## T020179-00-E HEPI Actuator 2 Assembly Oct 24 2002

### [Directory 1](#)

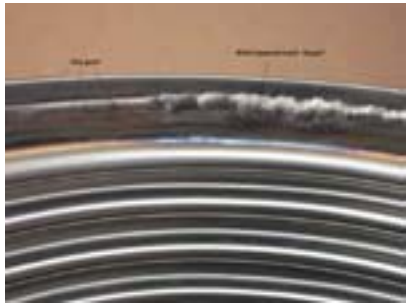
What can't be shown by a photograph is the waviness of the convolutions. This might not be a problem, but reflects the quality of the part.

[Suspect Weld 7.jpg](#)

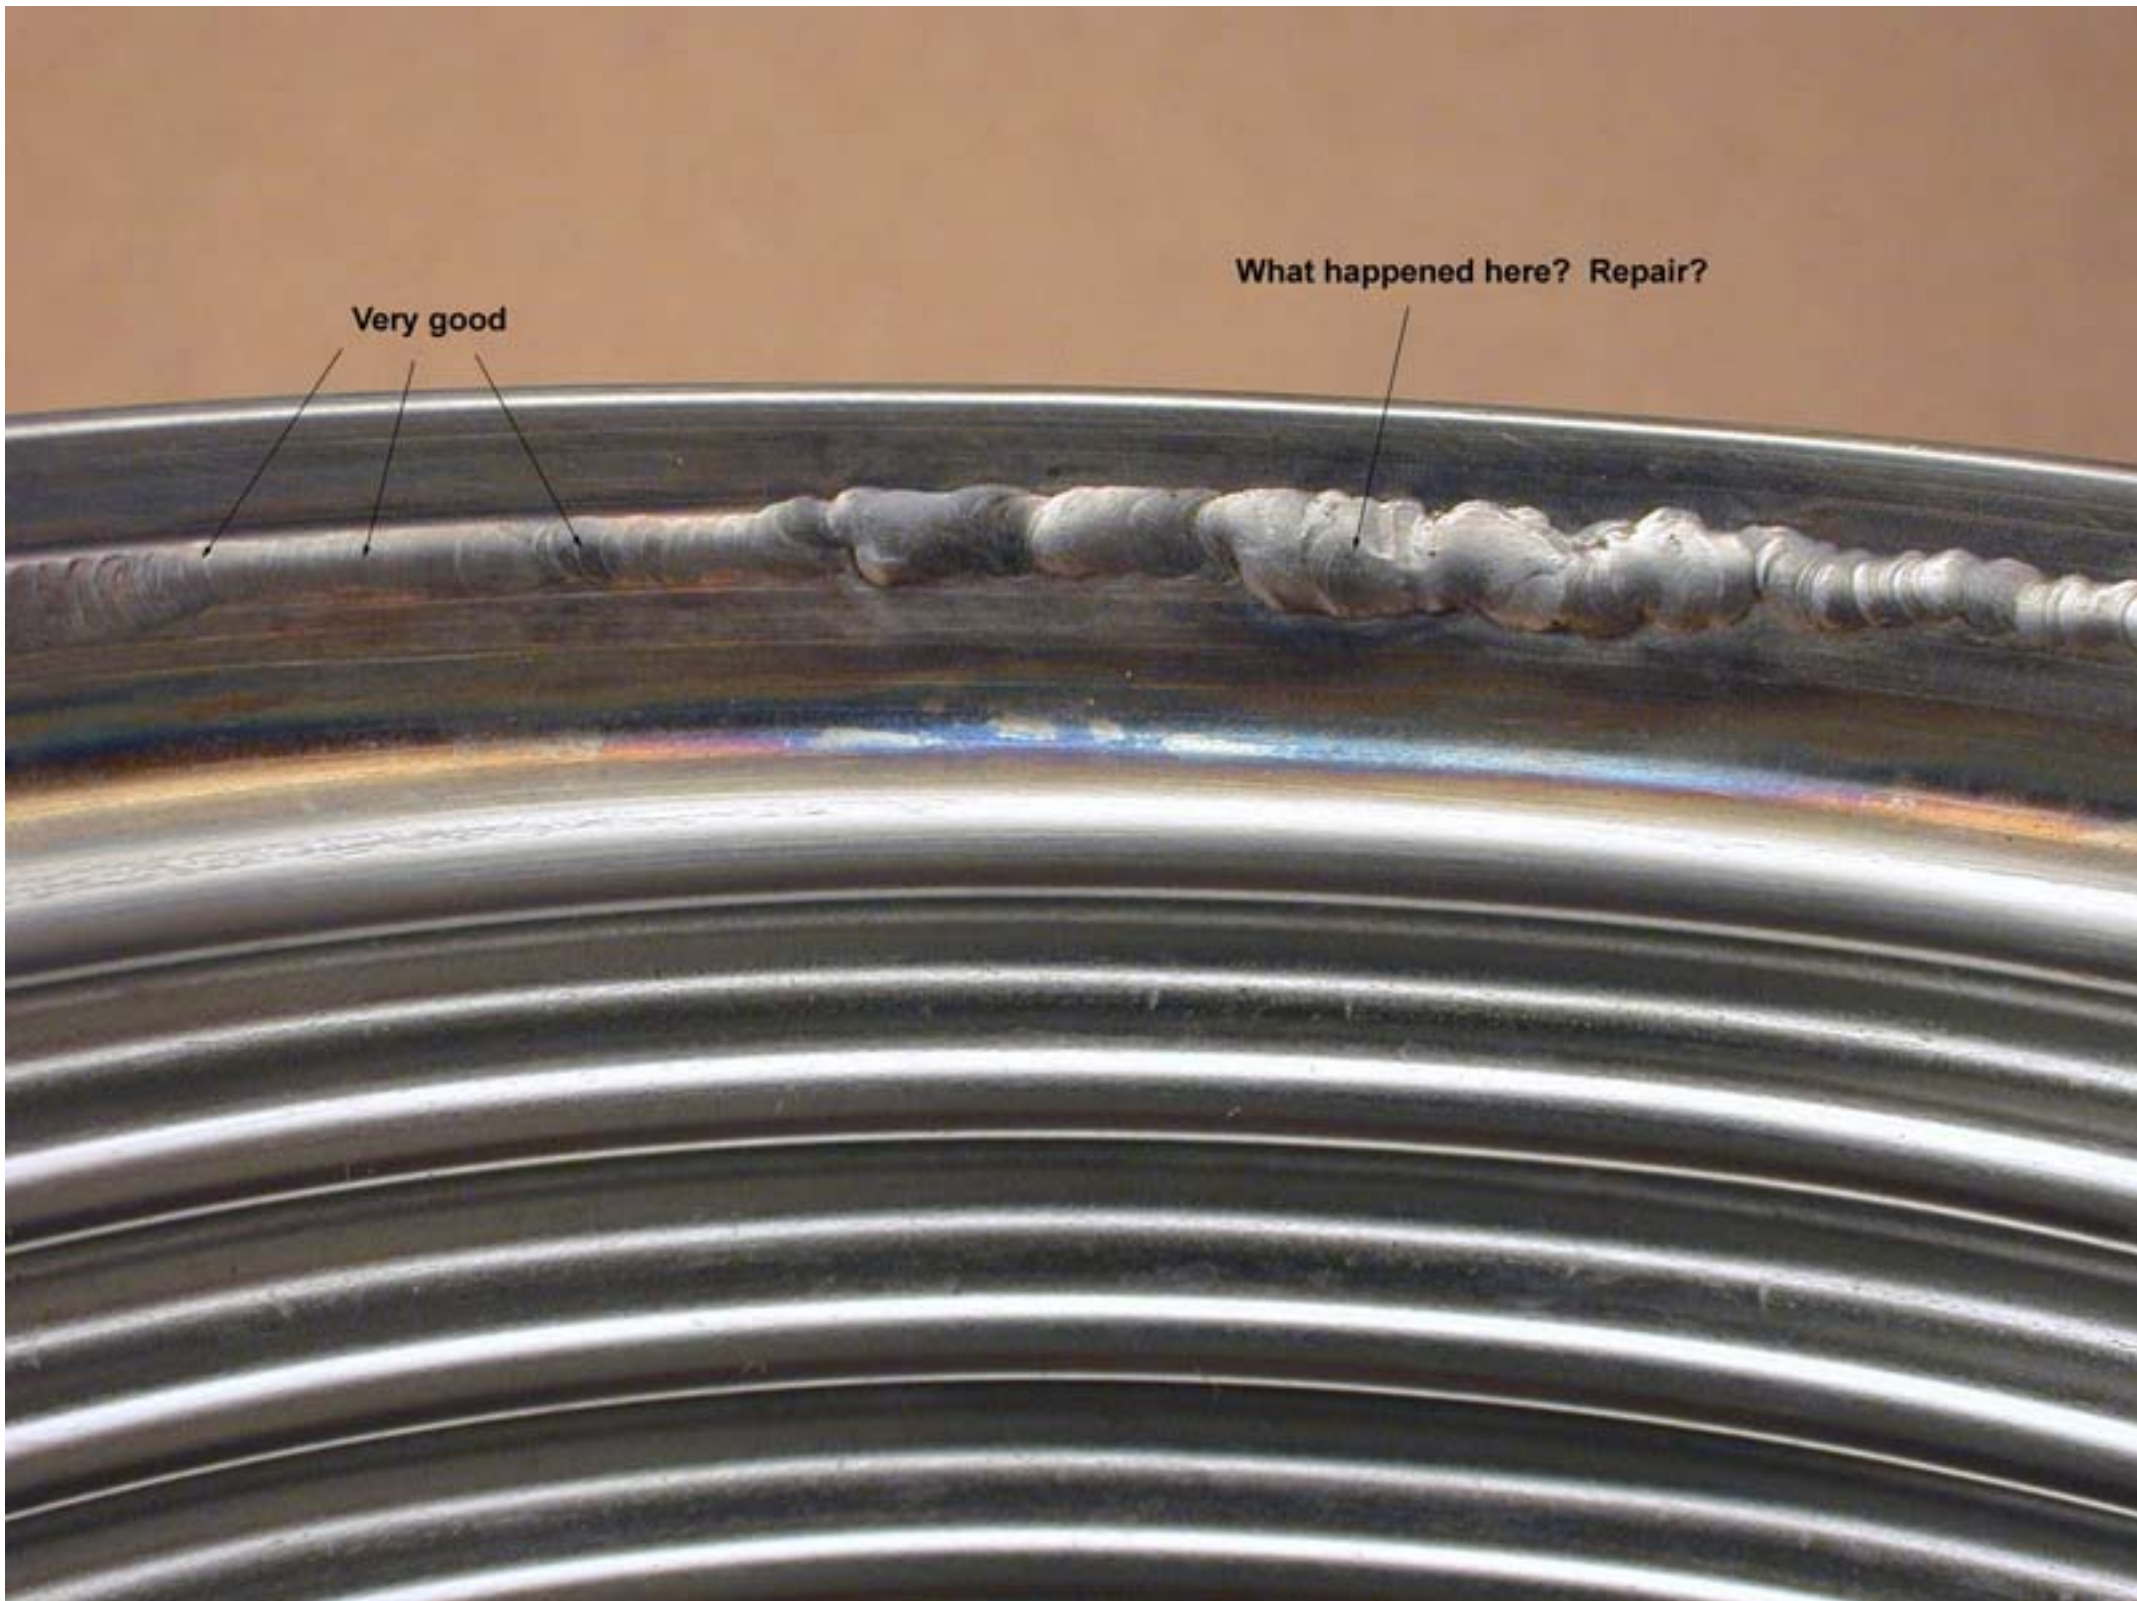
Here are some more pics of a Hyspan bellows that has many very questionable features. Some areas look like the welding proceeded well but there are areas that appear to have needed quite a lot of filler rod. Or it could have been areas that were welded and then needed to be repaired after it leaked. It would be very hard to tell which was the case.

What appears to be the resistance weld of the small weld assist band can be seen on the inside of the bellows as shown.

Note the inner weld assist band between the bellows and the large weld assist ring.

Also note the several places where the bellows does not sit flush with the surface by the weld.
